ADDENDUM 2 – JOB 4

TO: All prospective bidders on Project SC-3410(059), Job No. 4 scheduled for the November 9, 2018 bid opening.

Revisions for SC-3410(059)

SUBGRADE REPAIR (PATCHING)

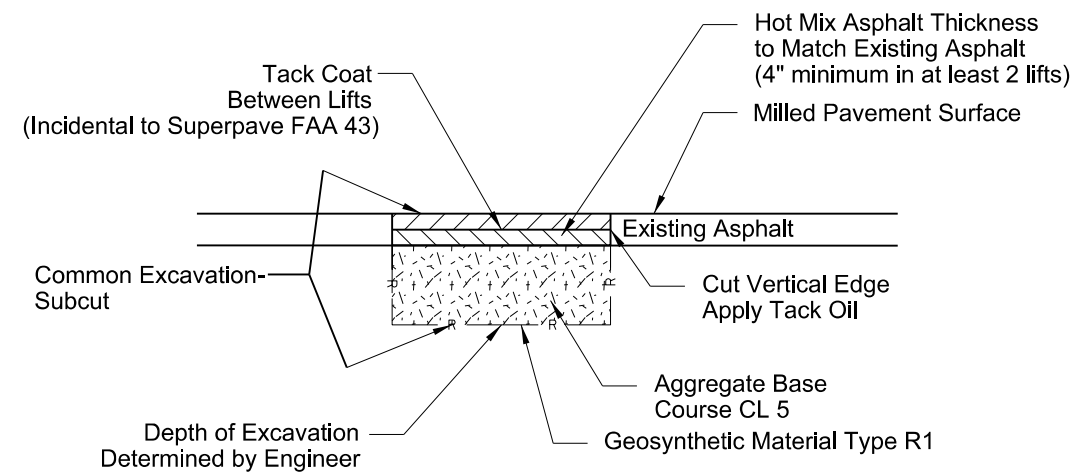
- Revised note 3 on the SUBGRADE REPAIR (PATCHING) detail to clarify patching operation.

- 1) Subgrade Repair at depths of 1 foot or greater shall be excavated to the full width of the lane and tapered at a ratio of 20:1 on the ends.
- 2) Geosynthetic Material Type R1 may be eliminated in the field by the Engineer.
- 3) Subgrade Repair (Patching) operation to be performed after milling operation.
